Restaurant Details- PopUp Bagels (20240325010002)

Re: **Establishment Reviewed:** PopUp Bagel
177 Thompson Street
Manhattan, NY 10012

Roadway Cafe Site Plan Form

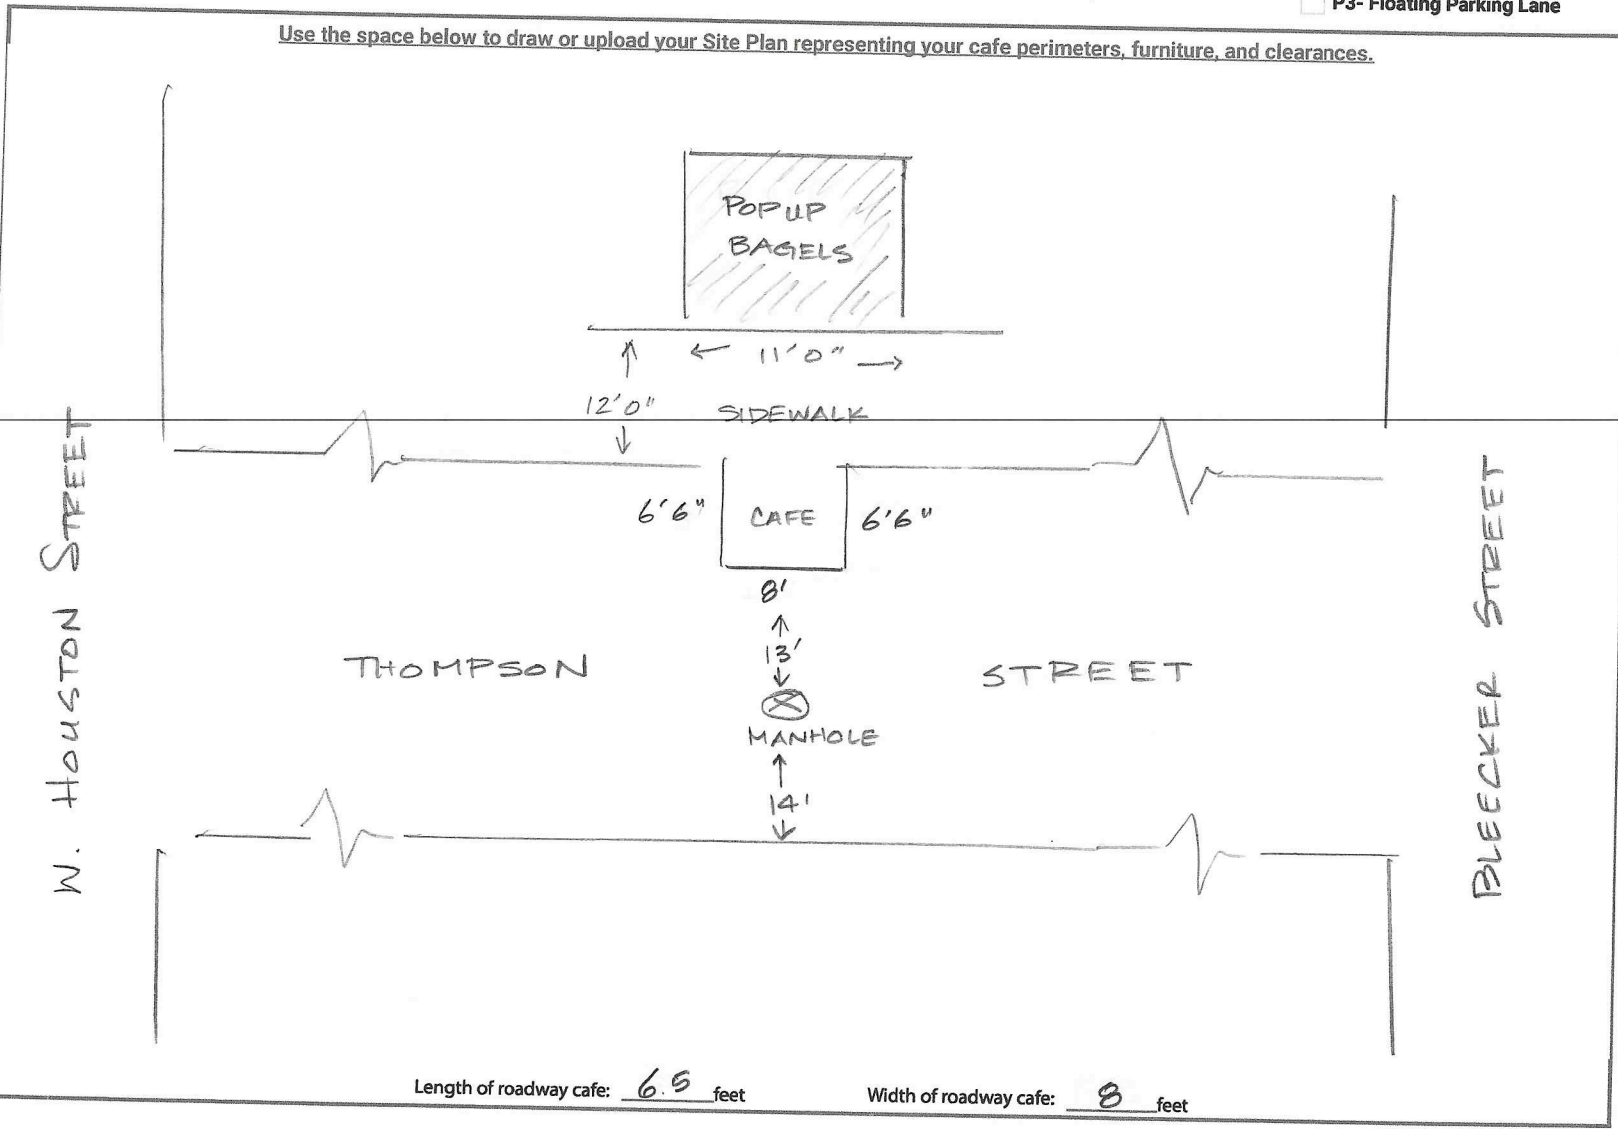
- The roadway is approximately 26' wide (curb to curb).
 - The applicant is proposing a structure that is 6' wide.
 - If implemented, the emergency travel lane remaining would be 12 feet wide.

<u>Criteria from memo: NYCDOT's Dining Out NYC Program:</u>	<u>FDNY City Planning Comments</u>
1.1 The FDNY does not encourage the implementation of such variances (Roadway Cafés that propose reducing the emergency travel lane width to less than 15'.	The proposed Roadway Café would reduce the emergency travel lane to 12'.

The proposed Roadway Café presents an obstruction having potential to negatively impact Fire Operations. However, the FDNY Bureau of Operations has determined the potential impact as minimal, and therefore, with coordination with local units, has **no objection** to implementation.

Applicant is required to contact Battalion 6, Engine 33, Ladder 9, (bat006@fdny.nyc.gov, eng033@fdny.nyc.gov, lad035@fdny.nyc.gov) prior to occupancy of the Roadway Café to provide familiarization. Considerations offered by the Administrative Company shall be applied to the approved Roadway Café as deemed necessary.
